Response to the Reviewers' Comments

The authors would like to thank the reviewers for the precious comments and suggestions on the technical contents and presentation of our manuscript “Runtime Power Management of Battery Electric Vehicles for Extended Range with Consideration of Driving Time,” submitted to IEEE Transactions on Very Large Scale Integration (TVLSI.) This revised manuscript has been greatly improved thanks to the reviewers' invaluable advices. We have revised the manuscript faithfully following the reviewers's comments. We include the newly added or significantly modified parts in the revised version of the paper also in Response to Reviewers. We highlight the important technical content changes and set those parts in a red color in the revised paper.

Fig. 1: (a) Range-speed experimental data for Chevrolet Bolt [36] and (b) comparison with simulation results of the proposed EV power model.

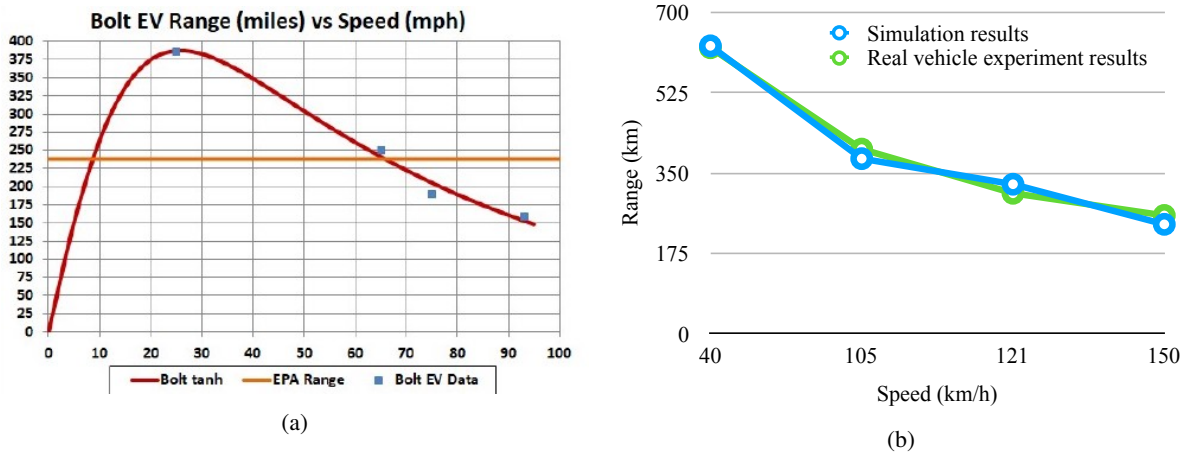
R1-C2 It is not clear how to validate the power model of EV. As the author mentions that accuracy of power model is quite important, it is good to see the power model in this paper can be validated by some real measurement results.

R2-C1 The paper claims that the proposed BEV power model is more accurate than those in the literature. While the results in Section V demonstrate the benefits of the proposed model and in some way indirectly show its accuracy, it would be good to have a direct comparison of model accuracy between the proposed model and those in literature, e.g., based on simulations as in Fig. 1.

In this paper, we use the same EV power model equation in [1], which has been proven to be accurate as long as the coefficients are appropriate. However, the model coefficients in [1] are only for low-speed, ultra light-weighted EV (a half metric Ton). However, we would like to demonstrate a more practical results that are applicable to production EVs. Therefore, all the coefficients should be updated for production-scale EVs in this paper.

Here goes how we extracted correct coefficients of the EV power equation. We use a vehicle simulator that supports EV as well, ADVISOR, to extract the coefficients of new vehicles starting from known vehicle specifications such as the aerodynamic resistance, rolling resistance, curb weight, and so on. Such data is often published in the users' manual, website and so forth. We further use the vehicle performance data such as the top speed, maximum acceleration, and so on, which are also available on the manuals and website. We iteratively run ADVISOR and derive the model coefficients so that all the known values match among each other. We evaluate the model accuracy with the range-speed real vehicle experiments as shown in Fig. 1(a), which has been published by [32], [33], [34], [35], [36]. We further refine the coefficients until all the available data values match well. Finally, the derived EV power model well matches with the range-speed experimental data as shown in Fig. 1(b) as well as the top speed and maximum acceleration, setting the aerodynamic resistance, rolling resistance, curb weight, etc. with the known (fact) values. The errors of the range-speed simulation is merely 1.4%, the time to approach 60 mph at departure is 7.8%, and the top speed is 3.0%, respectively. We revised the manuscript adding the following paragraph with a new figure in Section III-A on page 3 and 4.

We use ADVISOR to extract the model coefficients of new vehicles starting from known vehicle specifications such as the aerodynamic resistance, rolling resistance, curb weight, and so on. Such data is often published in the users' manual, website and so forth. We further use the vehicle performance data such as the top speed, maximum acceleration, and so on, which are also available on the manuals and website. We iteratively run ADVISOR and derive the model coefficients so that all the known values match among each other. We evaluate the model accuracy with the range-speed real vehicle experiments as shown in Fig. 1(a) [32], [33], [34], [35], [36]. We further refine the coefficients until all the available data values match well. Finally, the derived EV power model well matches with the range-speed experimental data as shown in Fig. 1(b) as well as the top speed and maximum acceleration setting the aerodynamic resistance, rolling resistance, curb weight, etc. with the known values. The errors of the range- speed simulation is merely 1.4%, the time to approach 60 mph at departure is 7.8%, and the top speed is 3.0%, respectively. The model coefficient extraction result shows as in Fig. 2. The normalized root-mean-square deviation is 5.1%. Table I summarizes the model coefficients of (5) for Chevrolet Bolt.

Fig. 12: Comparison of *EDP* for various energy-aware-velocity planning methods.

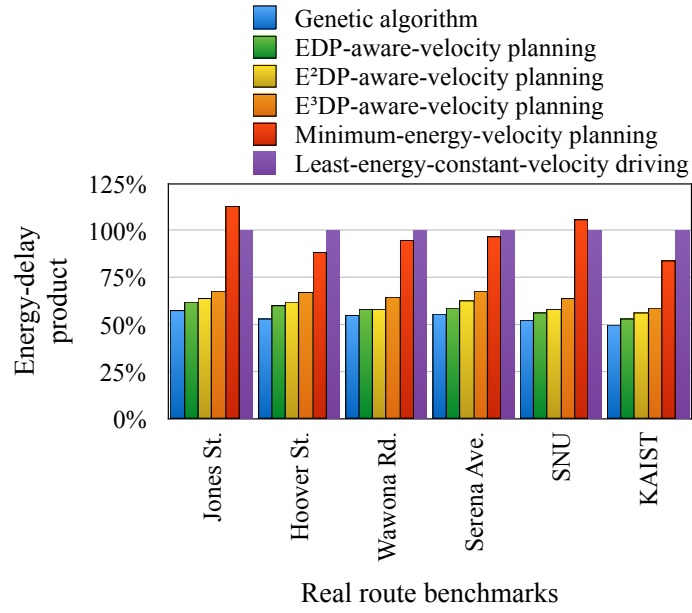
R1-C3 The optimality of the proposed scheduling algorithm is unclear. The author should add several paragraphs to discuss this topic. It is also to see the comparison baseline is well accepted to show the advantage of the proposed algorithm.

R1-A3 As we already mention in the previous version of the manuscript, the proposed EDP-aware-velocity planning is not optimal. This is because the EDP-aware-velocity planning is not formulated as DP (we also mentioned this in the previous version of the manuscript), but we used DP referring it as “heuristics.” We demonstrated that such heuristics method still very well reduces EDP , ED^2P and ED^3P . However, as the reviewer pointed out, there was no tangible clue how the resultant solutions are close to the true optimal.

In this revised manuscript, we did spend an extended period of time and added a new content how close the proposed heuristics method is to the true optimal, comparing with the results of Genetic algorithm (GA). GA can hardly be used for a practical solution method as its time complexity is not suitable for real applications. We use the GA results as a golden reference to evaluate the optimality of the proposed heuristics.

Fig. 12 shows EDP of the least-energy-constant-velocity driving, the velocity planning with EDP , E^2DP and E^3DP as a metric on various road benchmarks and the minimum-EDP-velocity planning with GA. The proposed velocity planning results in up to 47% improvements of EDP compared with the least-energy-constant-velocity driving. The improvements occur especially when the slope of the uphill is steep. The driving velocity on a flat road is faster than that of the least-energy-constant-velocity driving at the expense of relatively little energy to save driving time. Then, the velocity decreases when climbing the following uphill to spend less motor torque, which saves more energy.

In addition, the proposed EDP-aware-velocity planning is merely 7.8% higher than the true EDP-minimum-velocity planning on average. Through this results, we confirm that the results of the proposed heuristics are close enough to the true optimal solutions.

Fig. 13: Histogram of (a) velocity and (b) acceleration for various energy-aware-velocity planning methods.

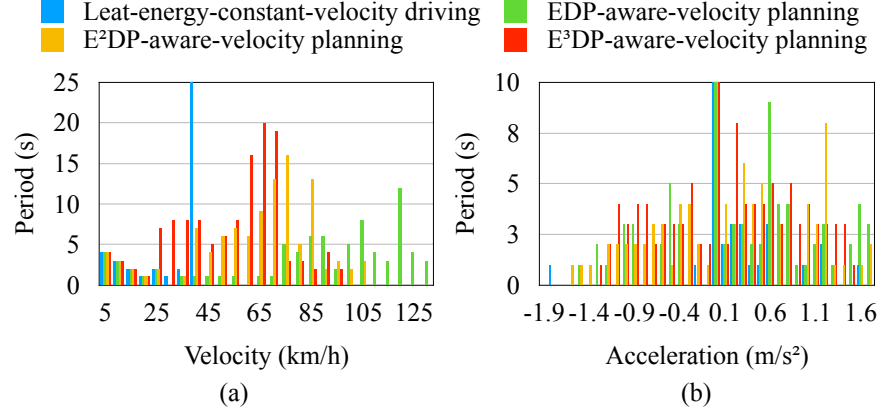
R2-C2 It would be good to have more discussion on the assumptions of the approach and the experiments, e.g., how much can the velocity be changed in practical scenarios without impeding traffic and causing unsafe situations (also depending on the road conditions and whether it is urban or rural environment I suppose). Currently, there only seems to be one constraint on not slower than 10 km/h.

R3-C2 Three different energy-delay product metrics are given in the paper. Can you recommend which one would be the best practical scenarios?

Of course, the least-energy-constant-velocity driving results in the least velocity and acceleration change, and thus it provides the maximum predictability and comfort. Compared with the least-energy-constant-velocity driving, the proposed methods, which are aware of EDP , E^2DP and E^3DP , keep changing the velocity by the road slope change and thus may impede traffic as the reviewer pointed out. It is unlikely to incur dangerous situations, but harsh braking and fast deceleration may cause uncomforness of passengers and potentially disturb safety assurance. In the revised manuscript, we add new analysis of the baseline and proposed methods (EDP , E^2DP and E^3DP) about the velocity and acceleration change. The newly added analysis is a histogram analysis of velocity and acceleration. We quantize the velocity and acceleration values and make a histogram as shown in Fig. 13. Thanks to the reviewer's comment, we had a chance to deeply look into the histogram analysis and revised the driving condition constraints.

We previously constrained that the EV should not drive too slow to avoid bothering traffic with the minimum speed of a 10 km/h. However, such velocity constraint is not realistic even in a city driving as the reviewer pointed out. We do agree on that more realistic minimum speed constraint is desirable, and thus we revised the constraint from 10 km/h to 25 km/h. Even with the new minimum speed constraint, we exhibit the same amount of gains with the proposed methods. After carefully analyzing the acceleration histogram, in this revised version of the manuscript, we newly enforce the minimum acceleration not lower than 0.4 m/s^2 when the EV starts from a stop sign or a traffic light until the velocity reaches to 25 km/h not too bother traffic flow. If the EV accelerates at a 0.4 m/s^2 , it would take 15 seconds to reach a 25 km/h speed. The previous version of the manuscript used the maximum acceleration limited by the motor torque: a 4.7 m/s^2 on a flat road. However, such a fast acceleration negatively affects to the power consumption as well as passenger comfortness. The revised version of the manuscript limits the maximum acceleration to 1.7 m/s^2 as shown in Fig. 13(b), which is the same as the maximum acceleration of compact cars designed to be primarily used in urban areas (15 seconds of 0 to 100 km/h time.)

We assume that the EV should not drive too slow to avoid bothering traffic with the minimum speed of a 25 km/h. Even with the minimum speed constraint as lower than 25 km/h, we exhibit the same amount of gains with the proposed methods. After carefully analyzing the acceleration histogram, we newly enforce the minimum acceleration not lower than 0.4 m/s^2 when the EV starts from a stop sign or a traffic light until the velocity reaches to 25 km/h not too bother traffic flow. If the EV accelerates at a 0.4 m/s^2 , it would take 15

seconds to reach a 25 km/h speed. The maximum acceleration is limited by the motor torque: a 4.7 m/s^2 on a flat road. However, such a fast acceleration negatively affects to the power consumption as well as passenger comfortness. We limit the maximum acceleration to 1.7 m/s^2 as shown in Fig. 13(b), which is the same as the maximum acceleration of compact cars designed to be used primarily used in urban areas (15 seconds of 0 to 100 km/h time).

We quantize the velocity and acceleration values and make a histogram as shown in Fig. 14 (Please refer R2-A2). For the EDP -aware-velocity planning, it is used when the deadline is the most important concern. Therefore, it is guided to drive at a speed of 75 to 130 km/h mainly regardless of the road slope. On the other hand, the E^2DP - and E^3DP -aware-velocity planning methods are used when the remaining battery state of charge is more concerned than the deadline. It is guided to drive at an energy-efficient speed along a road slope. Particularly, the E^3DP -aware-velocity planning method is used when the state of charge is more concerned, and the driver should find the nearby charging station. It is guided to decelerate to 25-40 km/h when climbing hills to further reduce energy consumption.

Fig. 9: Benchmark altitude.

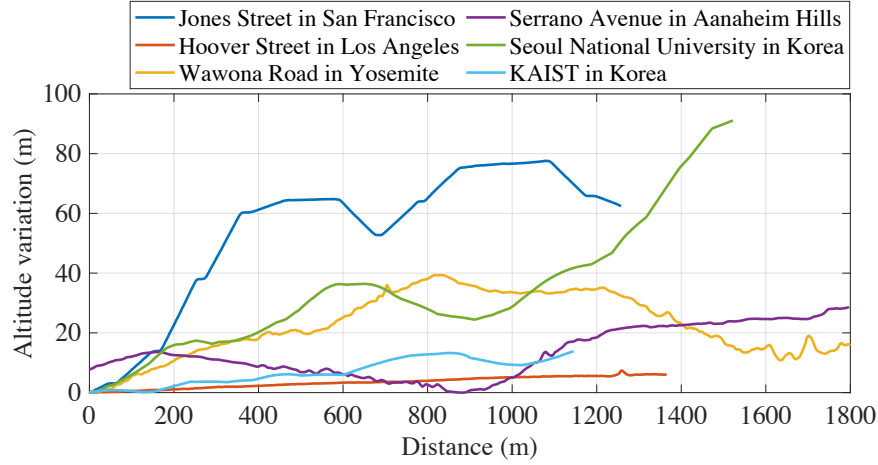
R2-C3 Related to the last point, it would be good to have more discussion on the road benchmarks, e.g., how they are generated and how representative they are. The optimization results significantly depend on road slope. It would be good to use a variety of real road segments for testing.

R2-A3 We appreciate the reviewer’s comment and added six new real routes from various locations in the world. First two routes consists of road segments in cities (San Francisco and Los Angeles, the two representative city landscapes such as hills and flat roads, respectively). The second two routes are road segments in mountain areas (Yosemite and Anaheim Hills in California.) The last two routes are university campus road segments. The details of route data is summarized in Table II and Fig. 9, which visualize the altitudes of the benchmarking routes.
